Title: Removal of the DCCH mapping on HS-DSCH: CRs on 25.301, 25.308 and 25.331 (Rel-5, Rel-6)

25.301 CR 070 # rev - # Current version: 5.2.0

25.308 CR 009 # rev **-** # Current version: **5.5.0**

25.331 CR 2424 # rev - # Current version: 5.9.0

Figure 5.2.2.1-1: Model of the UE's Downlink physical layer - HS-PDSCH with associated DPCH. HS-PDSCH is transmitted from cell 1 in this figure

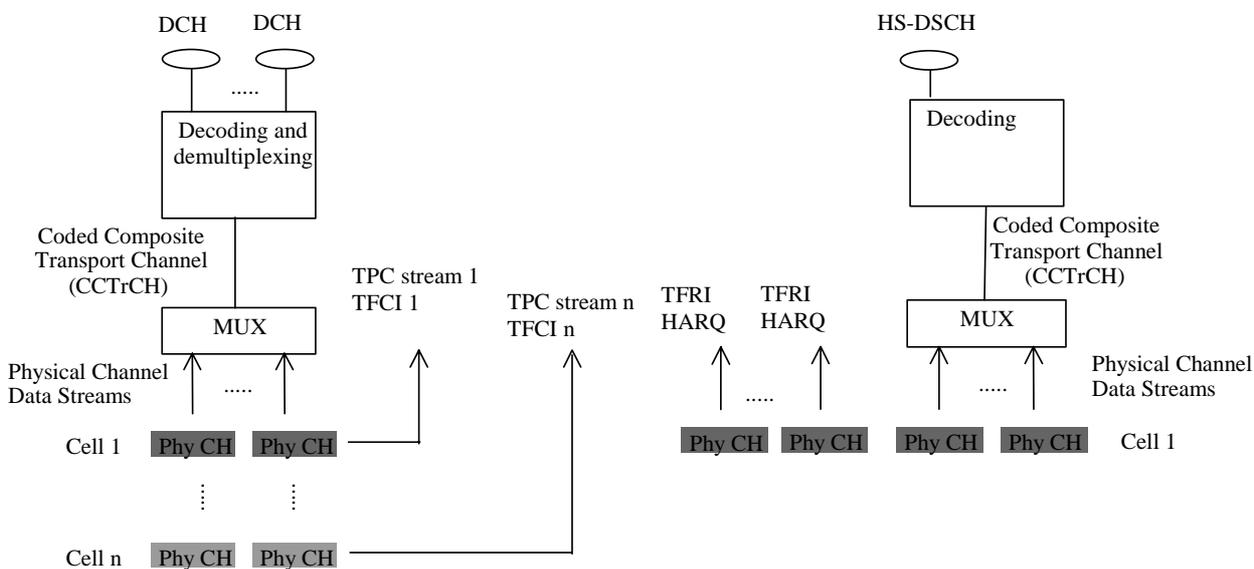
~~The upper layer signalling on the DCCH can be mapped to the DCH mapped to the associated DPCH or the HS-DSCH.~~

Figure 9.5-1: Inter-Node B synchronised serving HS-DSCH cell change after active set update

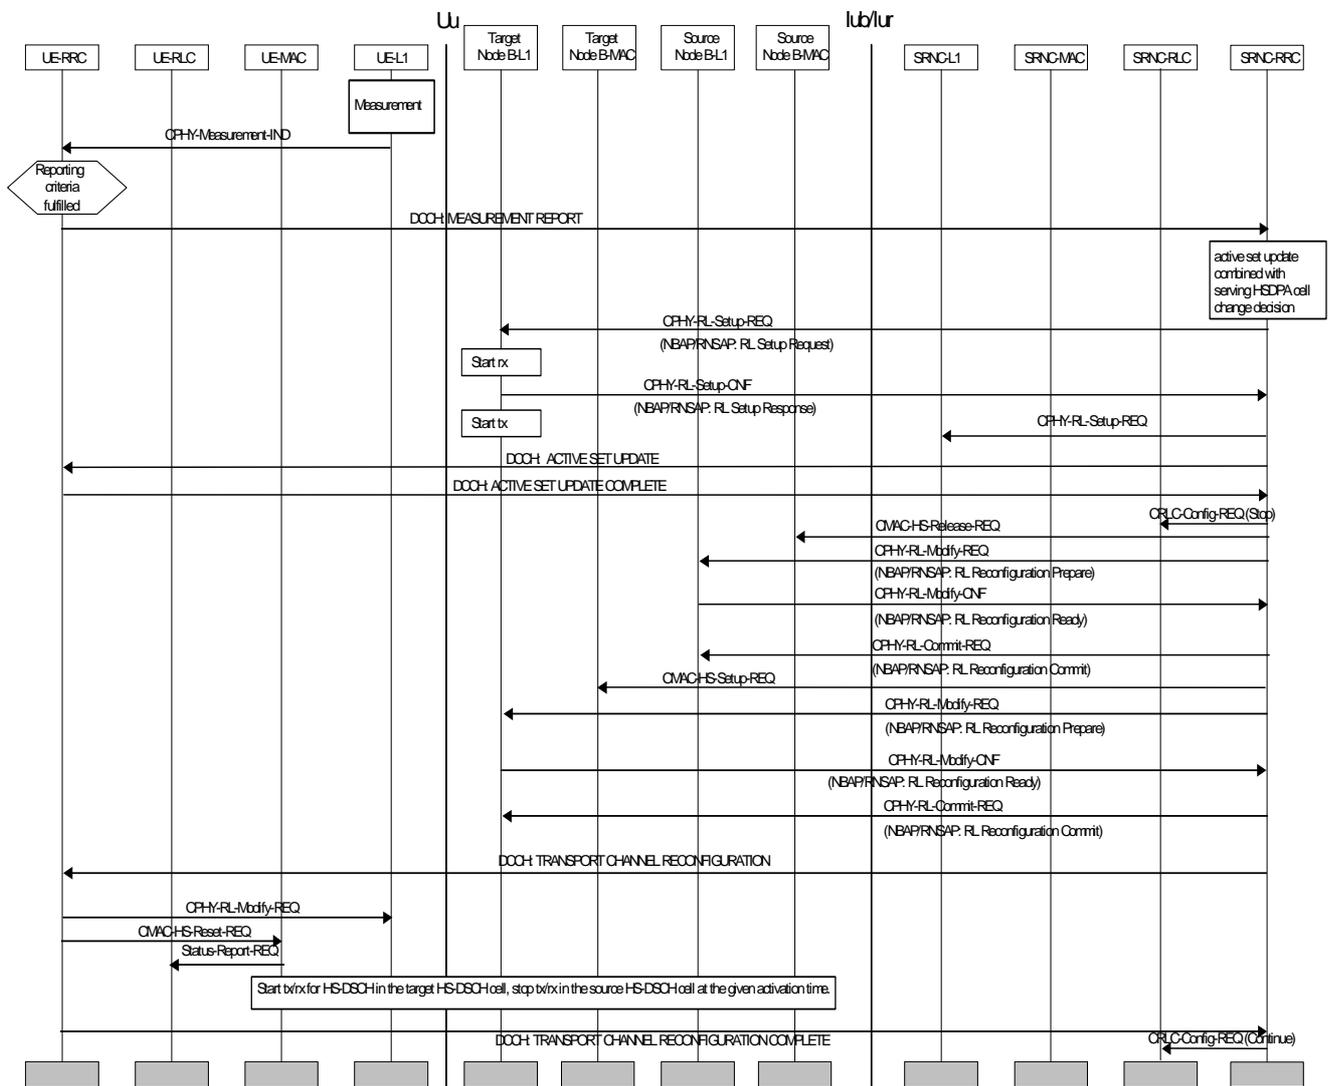
The SRNC then sends a TRANSPORT CHANNEL RECONFIGURATION message, which indicates the target HS-DSCH cell and the activation time to the UE. The message may also include a configuration of transport channel related parameters for the target HS-DSCH cell, including an indication to reset the MAC-hs entity and a status report for each RLC entity associated with the HS-DSCH should be generated.

When the UE has completed the serving HS-DSCH cell change it returns a TRANSPORT CHANNEL RECONFIGURATION COMPLETE message to the network.

Figure 9.4-1: Inter-Node B synchronised serving HS-DSCH cell change during hard handover

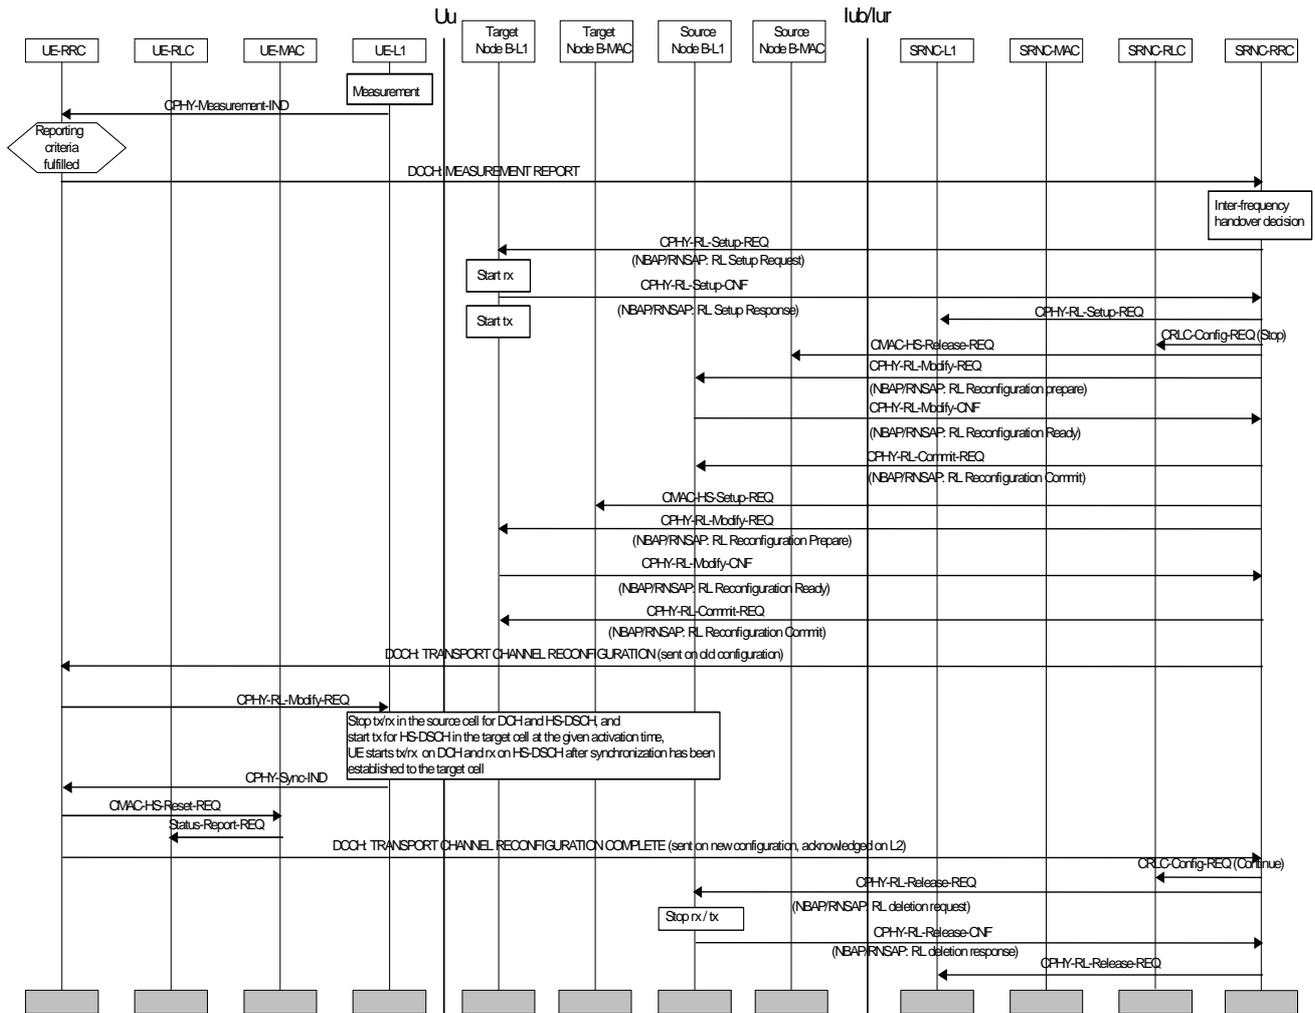
The SRNC then sends a TRANSPORT CHANNEL RECONFIGURATION message on the old configuration. This message indicates the configuration after handover, both for DCH and HS-DSCH. The TRANSPORT CHANNEL RECONFIGURATION message includes a flag indicating that the MAC-~~sh~~-hs entity in the UE shall be reset. The message also includes an update of transport channel related parameters for the HS-DSCH in the target HS-DSCH cell.

Reason for change:	# 1. In section 9.4 there is an error in a statement regarding a flag for MAC-hs reset (i.e. "MAC-hs reset indicator"). There MAC-sh is incorrectly mentioned instead of MAC-hs. 2. In section 9.5 TRANSPORT CHANNEL RECONFIGURATION is erroneously mentioned as a response message from UE to network.
Summary of change:	# The above items are corrected in each section.
Consequences if not approved:	# Inconsistency and incorrectness would remain in the specification. Impact on test specifications: No impact.
